LEXINGTON-FAYETTE URBAN COUNTY GOVERNMENT
CONTRACT CHANGE ORDER
 Page 1 of 2

| Project: | Government Center Parking Garage Repair | |
| | Change Order No. | 1 |

JUSTIFICATION FOR CHANGE

QTY. 7

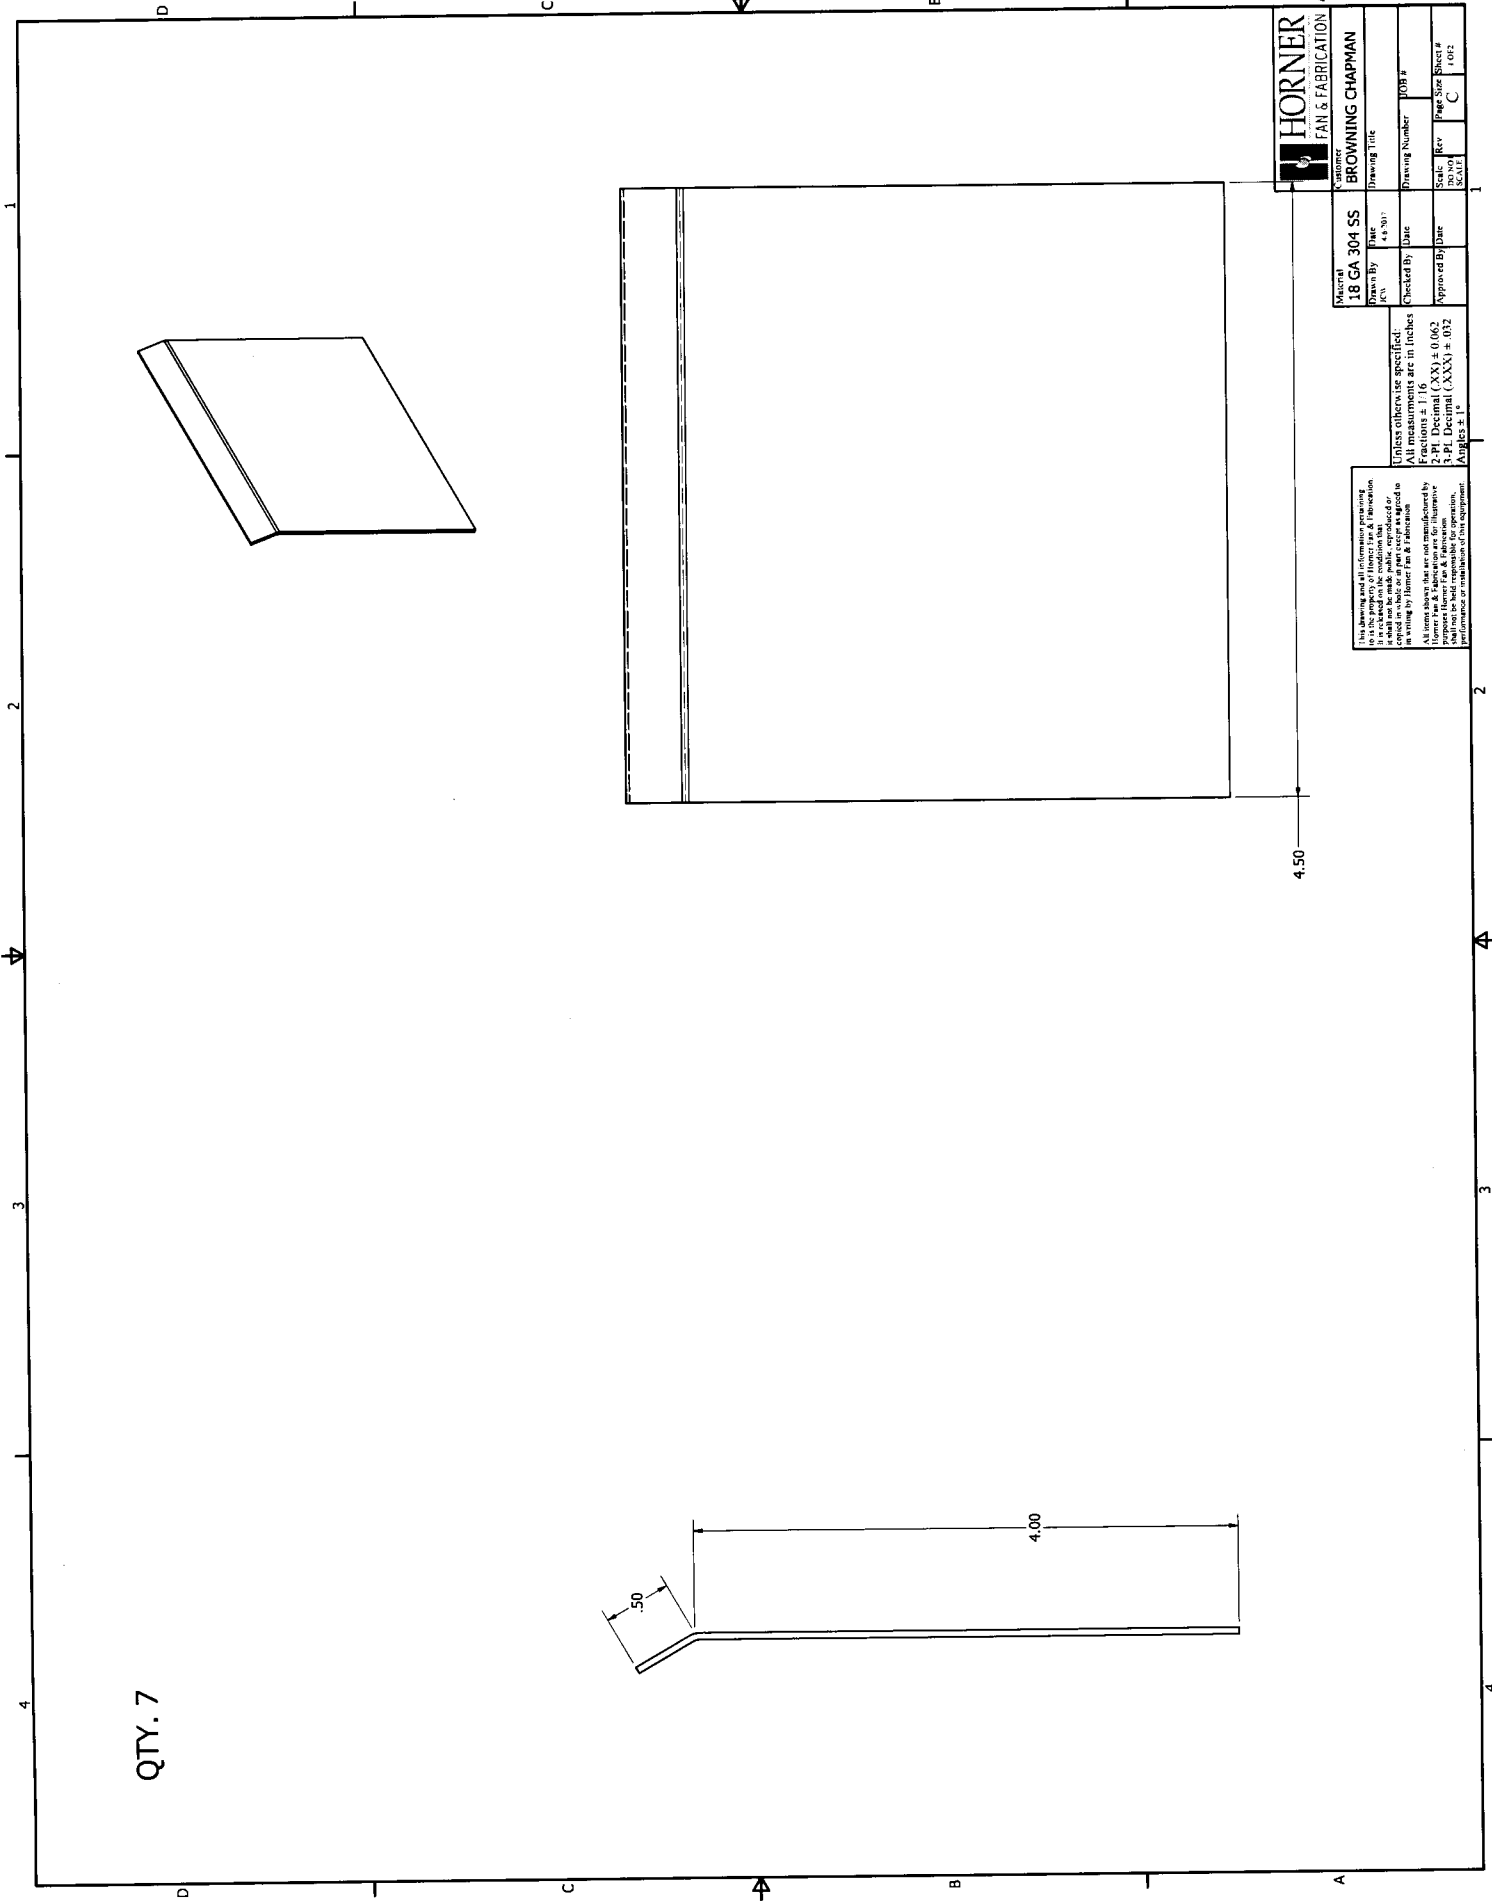
- Remove brick and re-install existing brick
- Replace lintel with new galv dipped lineal (Three sections)
- Install brick ties, membrane and flashing per THP detail.

1. Shore sections as needed and block door with proper signage.
2. Remove sections of brick, cut lintel and remove section.
3. Install new lintel and anchor. Place stainless steel flashing over steel lintel seems. Apply Carlisle waterproofing over anchors and Lintel.
4. Place posi-ties and set brick. Tuckpoint brick and misc areas on each side of entry.

- Steel lintel will be replaced in THree sections.
 - Price includes lift for access, signage and shoring.
 - Price includes re-using the existing brick. Sample mortar will be installed for approval.
- In new brick is needed, BC will match as close as possible.
